**Report to the Future Melbourne (Planning) Committee**

**Ministerial Referral: ID-2016-3 (Amendment GC44)  
Melbourne Convention and Exhibition Centre  
2-26 Clarendon Street, South Wharf**

### MINISTERIAL REFERRAL

<b>Application number:</b>	<b>ID-2016-3</b>
<b>DELWP Application number:</b>	<b>MBR029290 - Amendment GC44</b>
<b>Applicant / Owner / Architect:</b>	Urbis Pty Ltd / Plenary Group Pty Ltd / NH Architecture and Woods Bagot
<b>Address:</b>	Melbourne Convention Exhibition Centre, 2-26 Clarendon Street, SOUTH WHARF VIC 3006
<b>Proposal:</b>	Stage 2 of Melbourne Convention and Exhibition Centre - expansion of convention centre, new hotel and carpark
<b>Date received by Melbourne City Council:</b>	14 April 2016
<b>Responsible officer:</b>	Kate Yuncken
<b>Report Date:</b>	28 April 2016

3 INCREASE WIDTH AT NORTH, SHIFT STAIR 1 WEST

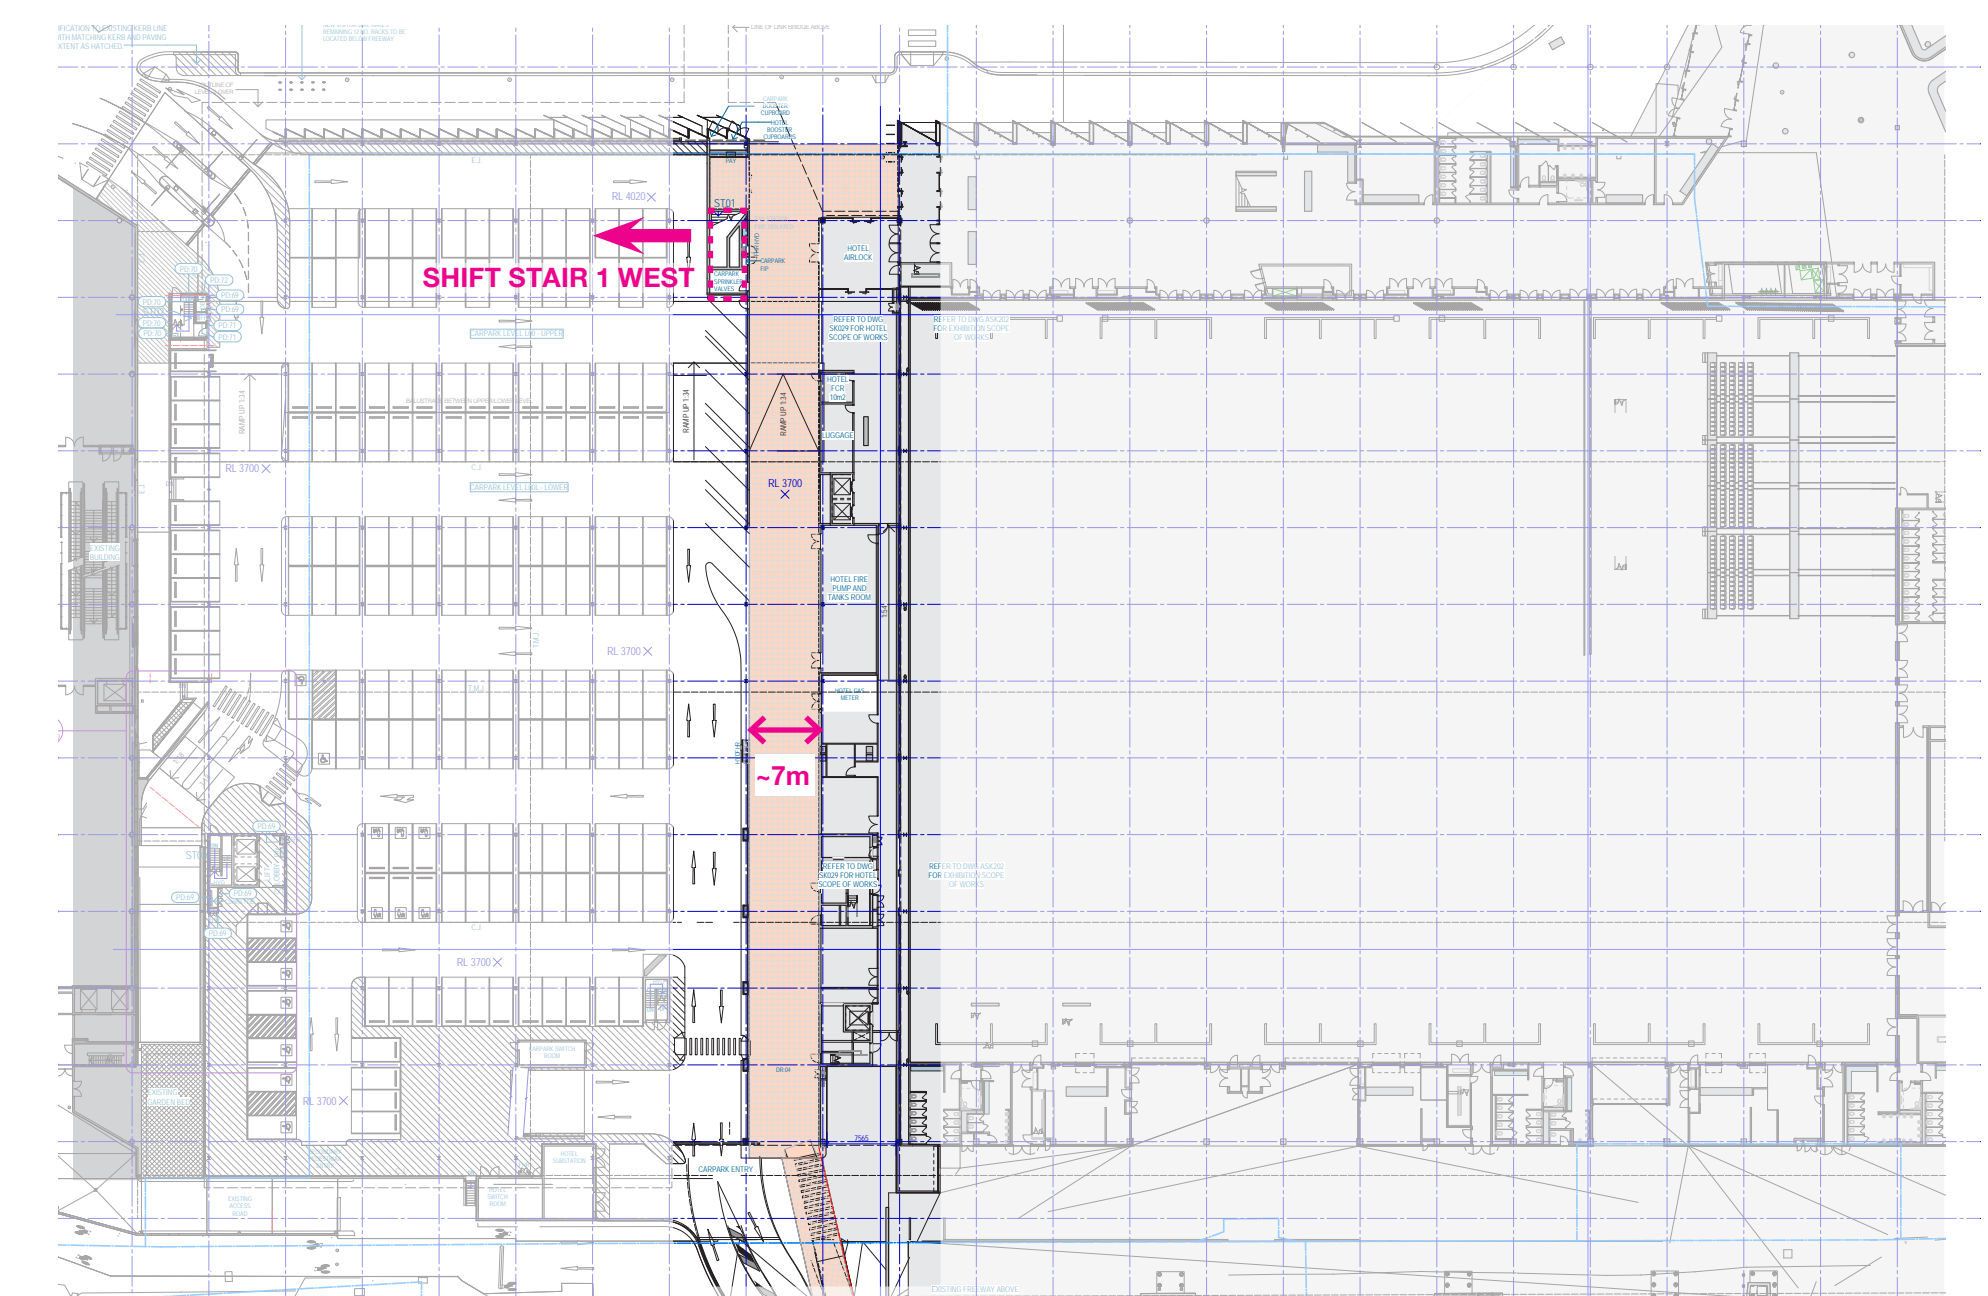
Several concerns have been raised by both the Urban Design and City Design team in regard to the north-south ground level pedestrian link that is bounded by the Exhibition Hall and Hotel on one side and the new multi-storey car park on the other. Concerns of safety, narrowness of the link, blind spots (poor sightlines) and attractiveness were raised and passed onto the applicant.

- The through block link has been widened to 7 metres and the ceiling heights have been increased to provide heights ranging from 3.7 metres to 5.5 metres.
- The detailing of the northern and southern entries to the link have been enhanced to create generous portals highlighting the entry points.
- The hotel has been moved 1.6 m further to the east to enable the provision of a straight link through the building.

Retail signage plan – Source: Application documentation

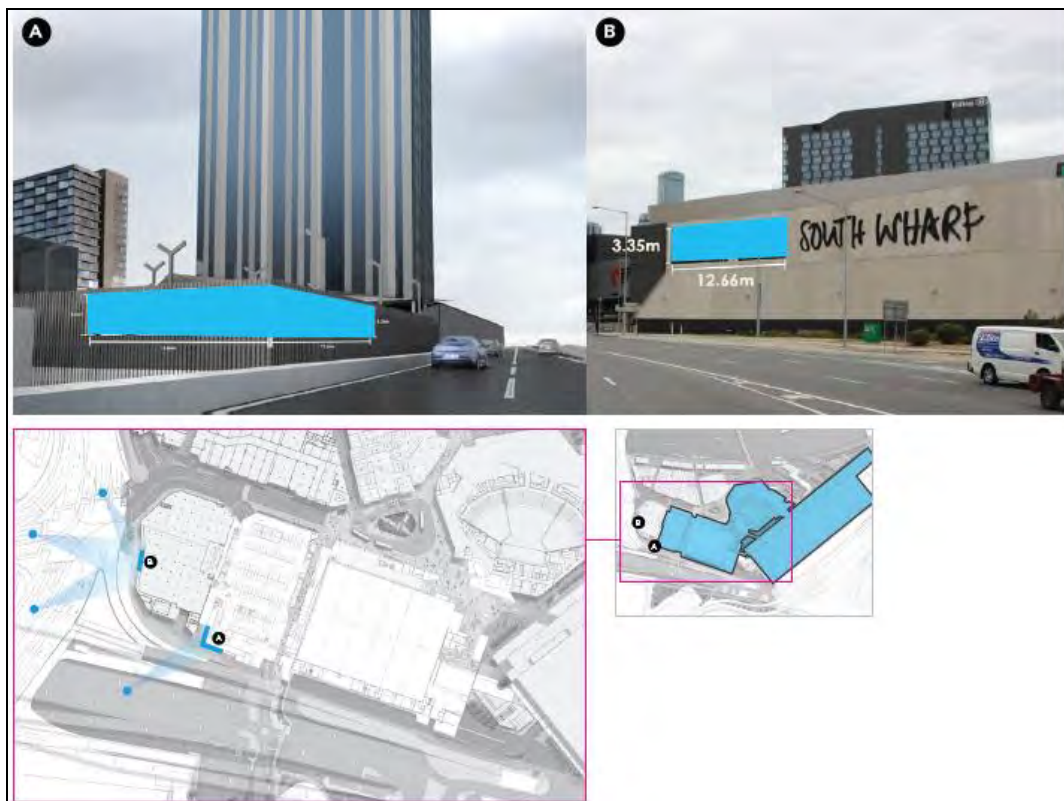
It is considered that the proposed advertising signage requires further resolution and should be considered under a separate planning approval.

- All proposed bicycle and motorcycle spaces to be shown on the plans to the satisfaction of Melbourne City Council – Manager Engineering.
- Removal of the two electronic major promotion signs and introduction of a mechanism requiring separate approval for major promotional signage.
